City Hall

Accessibility Review

Transition Plan - (location/priority)

Photo 2: Add handrails along the ramp to the break room (15).

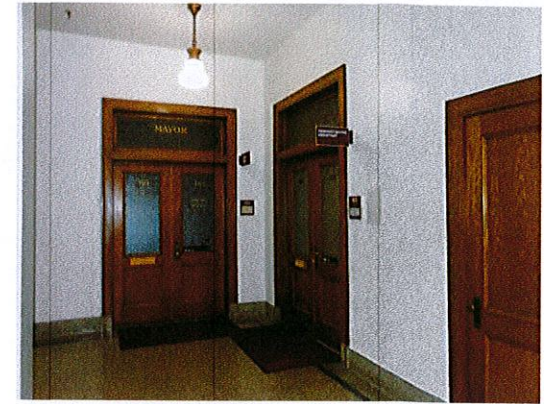
Location JQP # / Item #	Solution / Comments	Qty	Unit Cost	Total Cost	Priority	Estimated Compl. Date	Person Responsible	Actual Compl. Date	Actual Cost
100- Purchasing									
20A1 16924	Modify widths of double doors (1 large/1small) to provide a single leaf with a minimum 32" clear opening. ICC / ANSI 404.2.2	1	\$1,500	\$1,500	3				
101									
20A1 16923	Modify widths of double doors (1 large/1small) to provide a single leaf with a minimum 32" clear opening. ICC / ANSI 404.2.2	1	\$1,500	\$1,500	3				
102									
20A1 16922	Modify widths of double doors (1 large/1small) to provide a single leaf with a minimum 32" clear opening. ICC / ANSI 404.2.2	1	\$1,500	\$1,500	3				
107- Finance and Payroll									
20A1 16927	Modify widths of double doors (1 large/1small) to provide a single leaf with a minimum 32" clear opening. ICC / ANSI 404.2.2	1	\$1,500	\$1,500	3				
14									
15A 16942	Provide fully compliant handrails on both sides of the sloped surface. ICC ANSI 405.8 <i>Photo 2.</i>	34	\$25	\$850	3

Photo 3: Typical corridor doors are narrow double doors (a single leaf provides a 27" clear opening vs. 32" min) with knob style hardware.

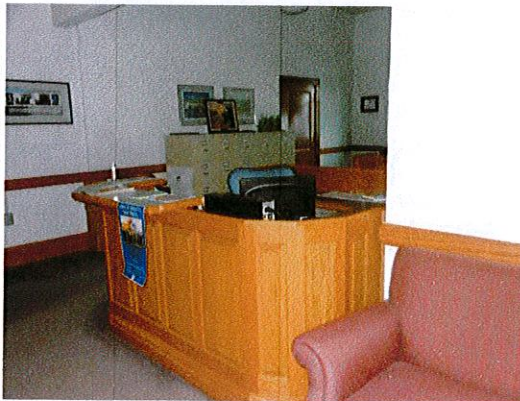
There are typically double doors into each of the departments from the main corridor. Currently a single leaf of the double doors provides a 27" clear opening. Modify the double doors to provide a single leaf with a 32" clear opening (options include a double door with 1 wide leaf and 1 narrow leaf or providing a single door with an sidelite).

Photo 4: Typical reception counters are at 40" throughout the building (vs. 36" maximum).

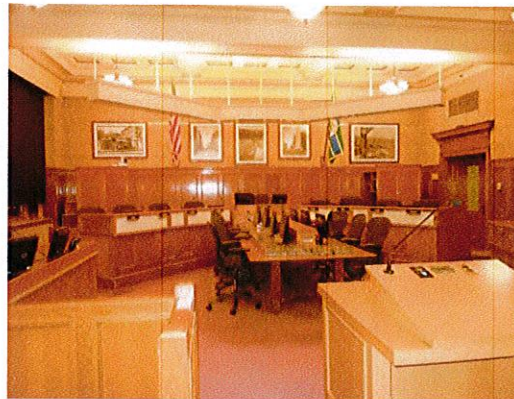
Location JQP # / Item #	Solution / Comments	Qty	Unit Cost	Total Cost	Priority	Estimated Compl. Date	Person Responsible	Actual Compl. Date	Actual Cost
407- Community Development									
20A1 16820	Modify widths of double doors (1 large/1small) to provide a single leaf with a minimum 32" clear opening. ICC / ANSI 404.2.2 <i>A single leaf of the double doors curently provides a 27" clear opening.</i>	1	\$1,500	\$1,500	3				
410- City Attorney									
14G1 16816	Eliminate protruding hazard by installing end panels or other object to direct a person with visual impairments using proper cane technique around the potential hazard. ICC / ANSI 307.1 <i>The in-box currently protrudes 15" at a height of 48".</i>	1	\$200	\$200	3				
21A1 16817	Lower a minimum 36" wide section of counter to a maximum height of 36" above the floor. ICC ANSI 904.3 <i>Currently at 40". Photo 4.</i>	1	\$1,000	\$1,000	3				
				<i>Location Subtotal:</i>					\$1,200

Photo 7: Relocate and lower the pay box on ground floor. It is currently a protruding hazard and the pay slot is located above the reach range.

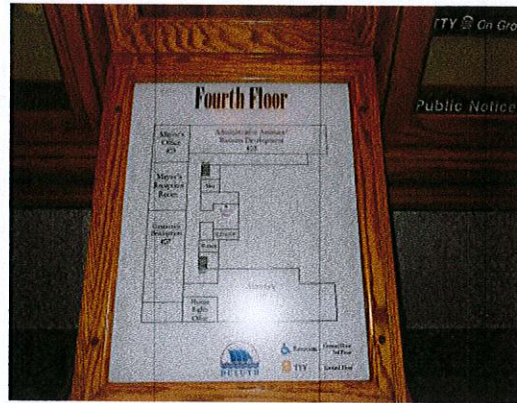
Parking Enforcement									
14F 16962	Lower object(s) so the highest operable part is no higher than 48". ICC / ANSI 308 <i>The slot of the pay box is currently at 56". Photo 7.</i>	1	\$50	\$50	3				
14G2 16963	Remove, relocate or replace object so it is not a protruding object for persons with visual impairments. ICC / ANSI 307.1 <i>The pay box currently protrudes 8" at a height of 41". (Cost already calculated.) Photo 7.</i>	1	\$0	\$0	3

Photo 9: View of typical women's toilet room. Features of accessibility are not provided in the multi-fixture toilet rooms. Post signs directing to the unisex accessible toilet room.

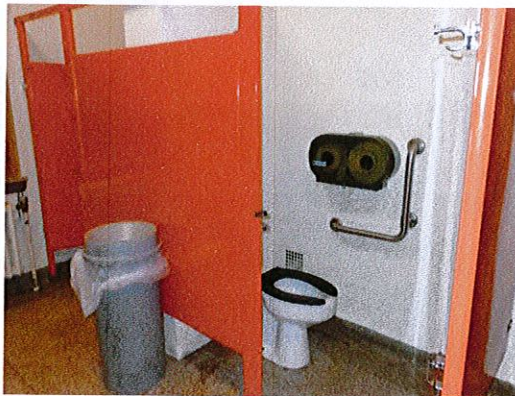
Location JQP # / Item #	Solution / Comments	Qty	Unit Cost	Total Cost	Priority	Estimated Compl. Date	Person Responsible	Actual Compl. Date	Actual Cost
Women's Toilet Room- 1st Floor									
22A2 16914	Install directional signage to the nearest accessible toilet room. MN 1341 1110.2, 1113.10.3.3 <i>Direct to the 3rd floor unisex toilet room.</i>	1	\$50	\$50	1				
Women's Toilet Room- 2nd Floor									
22A2 16878	Install directional signage to the nearest accessible toilet room. MN 1341 1110.2, 1113.10.3.3 <i>Direct to the 3rd floor unisex toilet room.</i>	1	\$50	\$50	1				
Women's Toilet Room- 3rd Floor									
22A2 16839	Install directional signage to the nearest accessible toilet room. MN 1341 1110.2, 1113.10.3.3 <i>Direct to the unisex toilet room on 3rd floor.</i>	1	\$50	\$50	1				
Women's Toilet Room- 4th Floor									
22A2 16806	Install directional signage to the nearest accessible toilet room. MN 1341 1110.2, 1113.10.3.3 <i>Direct to the 3rd floor unisex toilet room. Photo 9.</i>	1	\$50	\$50	1
